1 Products affected

Product hierarchy no. *				Part no.	SBU	Type / Description	Customer part no.
SBU	PG	PGU	Type				
02	005	116	0000001168	See list below	Power Entry Moduls w/o Filters	DD21 Power Entry Module	n.a.

2 Type of change

Old label with old configuration code	New label with new configuration code

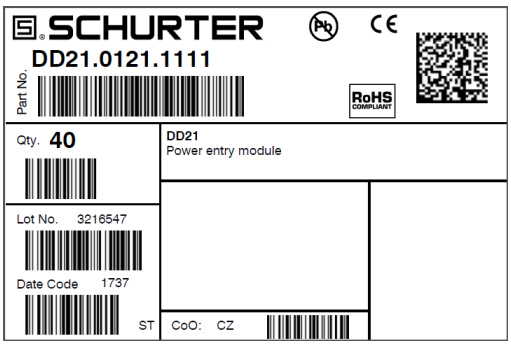
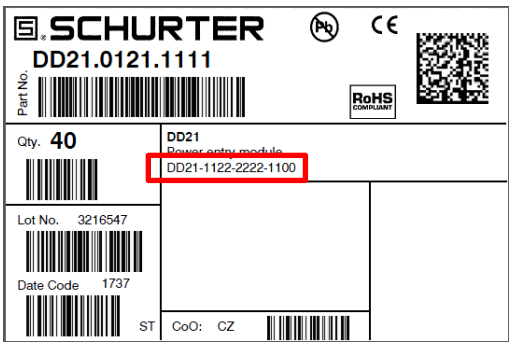
Change of plastic material from PET to PA6 (Socket)
Change of plastic material from PA6 to PA66/6 (Cover)
Inclusion of configuration code on label
